CITY PLANNING COMMISSION

- APPLICATION:
- A. Negative Declaration
 - B. Rezone 3.3+ acres from Agricultural (A) to Townhouse (R-1A) zone
 - C. Tentative Map to divide 3.3+ acres into 19 lots for development of 16 halfplex condominiums to be known as Mariner Oaks.
 - D. Special Permit to develop 16 halfplex condominium units
 - E. Subdivision Modification to waive standard subdivision improvements

LOCATION: 7456 Pocket Road

PRELIMINARY LANDSCAPE PLAN AND SITE PLAN
MARINA OAKS
CITY OF SACRAMENTO, CALIFORNIA

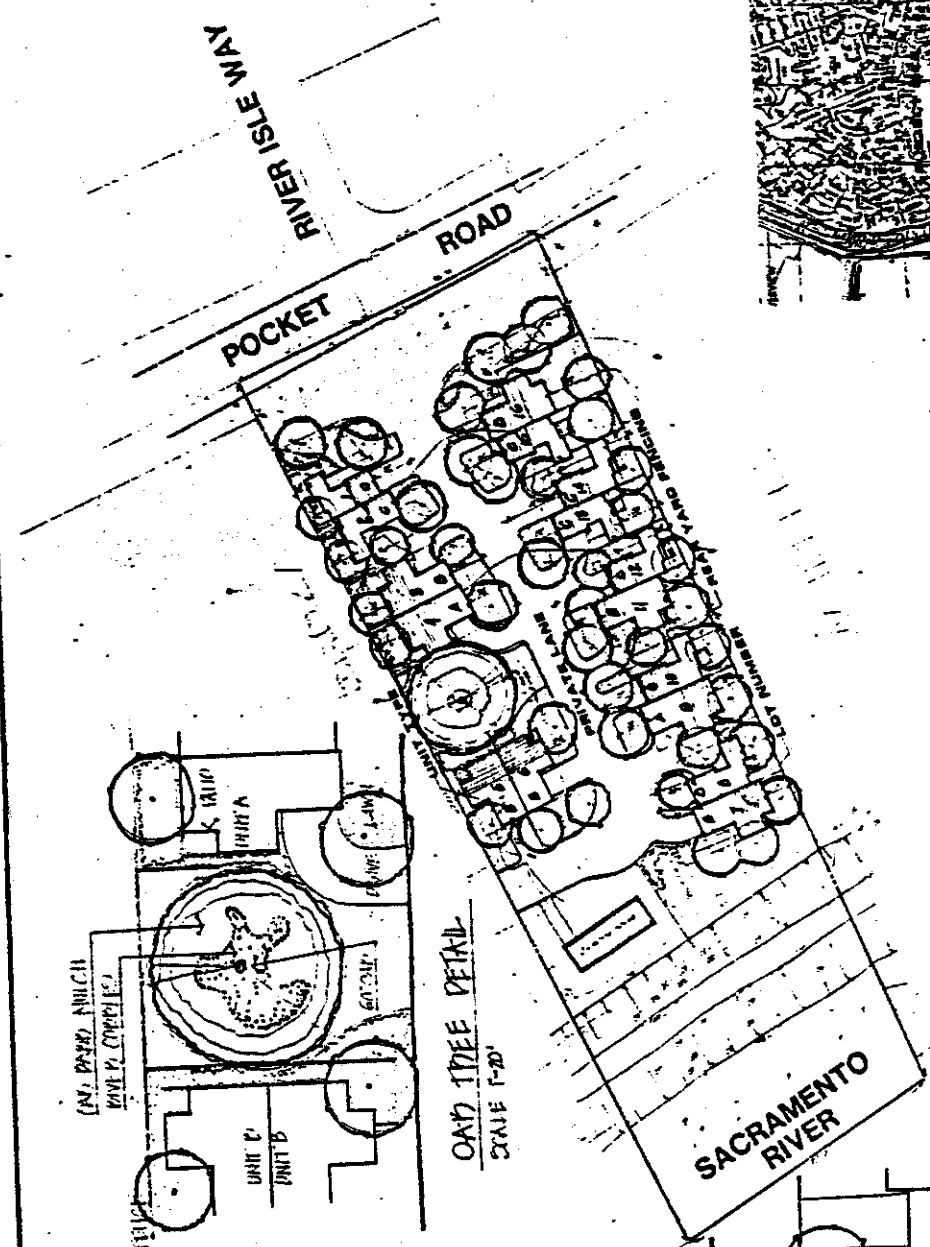
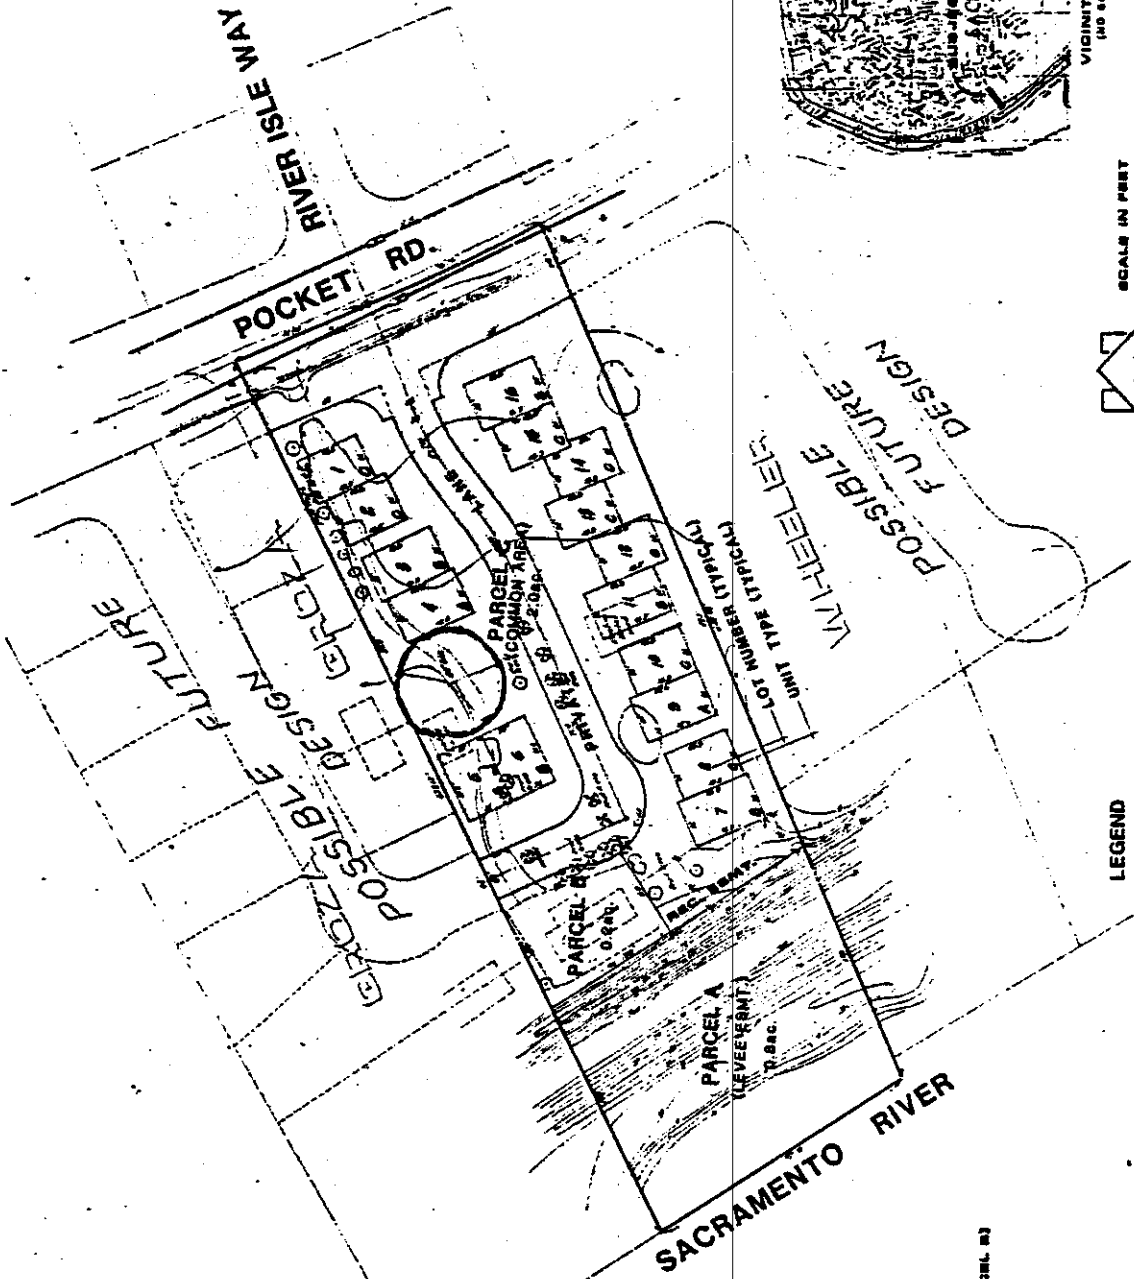
- A. The major issue regarding this project relates to the request by the applicant to construct a ~~private~~^{public} street through the subject site ~~rather than a private street~~^{without sidewalks}. The Subdivision Review Committee, by a vote of five ayes and four absent, denied the request to waive sidewalk improvements.

The applicant is proposing a 30-foot wide ~~private~~^{public} street with curb and gutter, but no sidewalks. The Planning staff, upon reconsideration, supports the applicant's request to waive sidewalk improvements for the following reasons:

1. Due to the narrowness of the lot depths (80' to 90' along most of the street), five-foot wide sidewalks on each side of the street would reduce the front yard landscape setback areas to 17 feet in most cases. The staff would prefer the five-foot strip be developed with landscaping rather than as a sidewalk.

2. The length of the proposed street is only 320' to 340' (approximately the length of a Central City block); therefore, omitting a sidewalk for this short segment should not pose any undue hardship for pedestrians.

3. The applicant proposes a loop street through the adjacent parcel to the north as a possible future street design. This parcel, although slightly wider than the subject site, is still too narrow to develop with standard 100-foot lot depths for the entire subdivision. It is likely that a similar R-1A type development for a portion of the adjoining parcel would occur in the future. If this should be the case, a similar request to waive sidewalk improvements is also likely.

- B. The applicant proposes a combination of one and two-story halfplex units, with horizontal masonite wood siding and decorative masonry trim elements. The driveways are combined in many cases to minimize curb cuts. The staff requests that the roof materials be a medium wood shake and the garage doors of decorative metal rollup design. The applicant shall also install landscaping consisting of deciduous and evergreen trees, shrubs and live lawn as ground cover in all yard areas facing the private street and Pocket Road. An irrigation system shall also be installed.

- 1. The applicant shall construct the halfplex units as shown in the submitted plans. The exterior building materials shall consist of horizontal masonite wood siding with decorative masonry details, medium wood shake roofs and decorative rollup metal garage doors.

- 2. The applicant shall install front yard and street side yard landscaping and irrigation system. The landscape material shall consist of 15-gallon deciduous and evergreen trees, five and one-gallon shrubs and live lawn for ground cover. The detailed landscape and irrigation plan shall be submitted to the Planning Director for review and approval prior to issuance of building permits.

- 34. The applicant shall plant a 24-inch box or larger specimen Walnut tree on the property, in an area that will promote its growth. The replacement of this tree, to the satisfaction of the City Arborist, shall occur prior to issuance of the final inspection permit for this project.

- 45. The applicant shall insure protection and preservation of the 60-inch Oak by complying with the following measures, to the satisfaction of the City Planning Director and City Arborist, prior to the issuance of a building permit.

TENTATIVE MAP
MARINA OAKS
 CITY OF SACRAMENTO CALIFORNIA

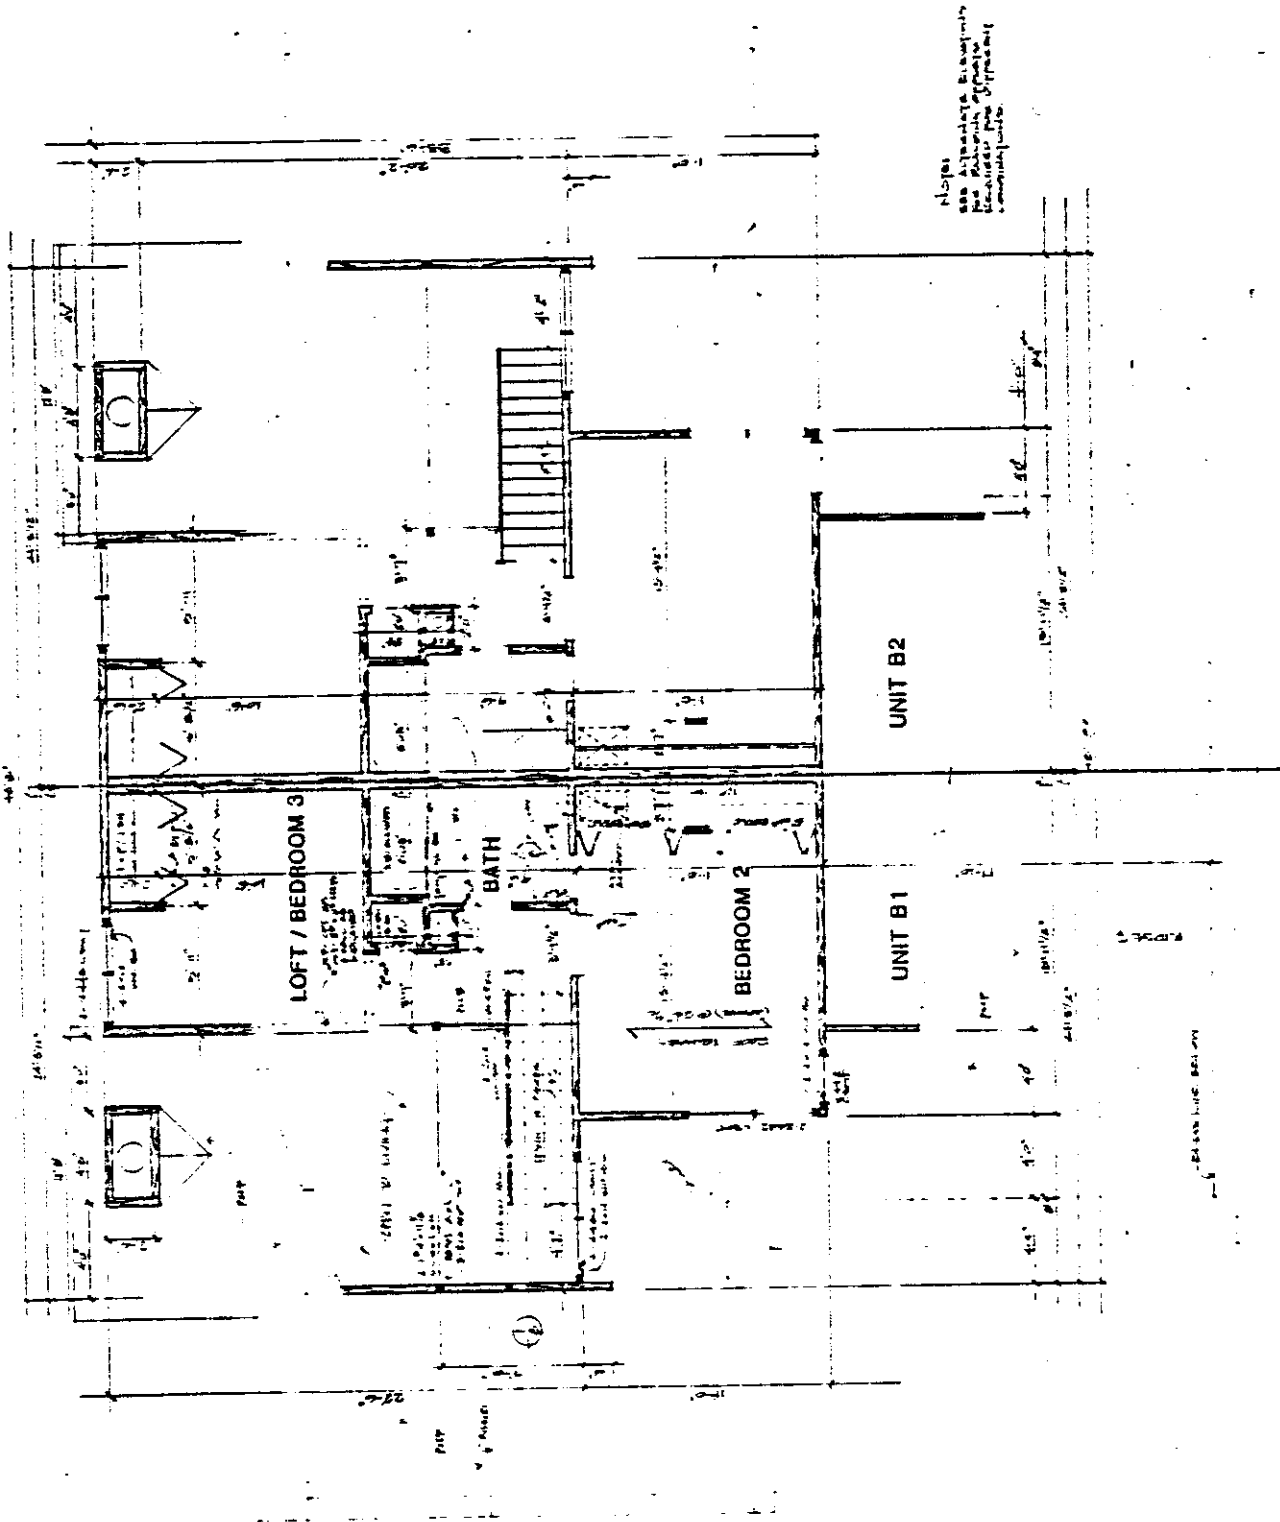
The Subdivision Review Committee recommends approval of the tentative map. The applicant shall satisfy each of the following conditions prior to filing the final map unless a different time for compliance is specifically noted:

- 1. Provide standard subdivision improvements, excluding sidewalks, pursuant to Section 40.811 of the City Code along Pocket Road and 44-foot right-of-way on interior street.

- 2. Prepare a sewer and drainage study for the review and approval of the City Engineer.
- 3. Pursuant to City Code Section 40.1302 (Parkland Dedication), the applicant shall submit to the City an appraisal of the property to be subdivided and pay the required parkland dedication in-lieu fees. The appraisal shall be dated not more than 90 days prior to the filing of the final map.

- 4. Pursuant to City Code Section 40.319-1, the applicant shall indicate easements on the final map to allow for the placement of centralized mail delivery units. The specific locations for such easements shall be subject to review and approval of the City Engineer after consultation with the U.S. Postal Service.

- 5. The applicant/developer shall designate and place on the final map those structures and/or lots which will meet the required 80 percent south orientation (including solar access) to the satisfaction of the Planning Director, or comply with Title 24 requirements of the Uniform Building Code.

- 6. If unusual amounts of bone, stone, or artifacts are uncovered, work within 50 meters of the area will cease immediately and a qualified archaeologist shall be consulted to develop, if necessary, further mitigation measures to reduce any archaeological impact to a less than significant effect before construction resumes. A note shall be placed on the final improvement plans referencing this condition.

- 7. Dedicate Lot A to the City for Sacramento River Parkway purpose.

8. Submit a seepage study prepared by a registered engineer. The study shall identify and recommend solutions for ground water related problems which may occur, both within the subdivision lots and public right-of-way. Appropriate facilities shall be constructed to alleviate these problems.
9. Street grades shall be designed for stabilized, subgrades and pavement sections under high ground water conditions.
10. A homeowners' association shall be formed, and the CC&R's shall be approved by the City Attorney and recorded.
11. Dedicate right-of-way along Pocket Road as per study on file with the City.
12. Pay Pocket Bridge fees.
13. Pay off existing assessments.
